SUBJECT: REQUEST FOR ADDITIONAL INFORMATION FOR THE REVIEW OF THE
MODEL NO. HI-STAR 100MB PACKAGE

**Request for Additional Information
HOLTEC INTERNATIONAL
Docket No. 71-9378
Model No. HI-STAR 100MB Package**

By letter dated October 25, 2019, Holtec International submitted an amendment request to Certificate of Compliance No. 9378 for the Model No. HI-STAR 100 MB transportation package.

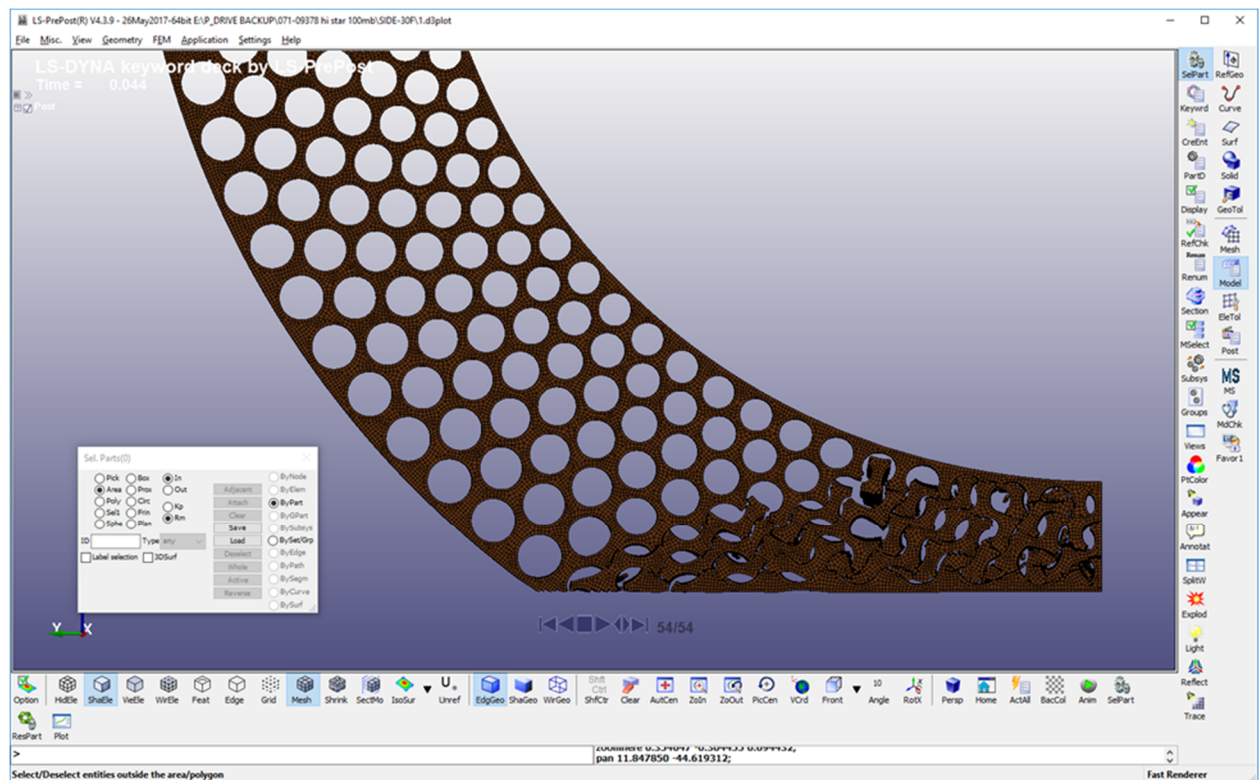
2-2 Justify and clarify the material modeling assumptions used to describe item 4, the perforated aluminum 6061-T6 impact limiter component.

Item 4 of (perforated impact limiter) on Drawing 11758, Sheet 1 is made of 6061-T6 aluminum which goes to failure (fracture) in the 9 m side drop simulation (part ID 121 in LS-DYNA) as shown below:

The material model used is material model 120 (024), or:
MAT_PIECEWISE_LINEAR_PLASTICITY_(TITLE)(024).

A failure strain of 0.426 (true strain) has been specified (engineering strain of 53.1); however, this material model does not account for strain rate, triaxiality, or uniform elongation.

Reference 2.2.6 in the application, "Properties of Aluminum Alloys, Tensile, Creep, and Fatigue Data at High and Low Temperatures, ASM International, November 2006" reports a typical failure strain of only 17% (engineering strain) or a true strain of 0.157 at room temperature, which depends heavily on the product form. However, simulation results show effective strain rates greater than 5,000 in the 9 m side drop scenario.

Minimum allowable engineering failure strains for ASTM 6061-T6 are lower, approximately 8-10%, depending on the product form. Poisson's ratio has also been set to 0.33 when it appears it should be 0.3.

Since supplied material properties of aluminum are most likely to be larger than those tabulated in ASME (i.e. yield strength) or have smaller values than those reported for elongation, it is reasonable to expect that higher loads will be observed by item 4 and thus potentially fracture under smaller ductility demands.

The applicant shall describe the condition of the package for all simulated drops that utilize strain rate, Poisson's ratio, triaxiality, minimum allowable elongation, and both minimum and maximum ASME yield strength values in order to model Item 4, which is made from aluminum 6061-T6. The applicant shall update the calculations and simulations reported in the application, as necessary.
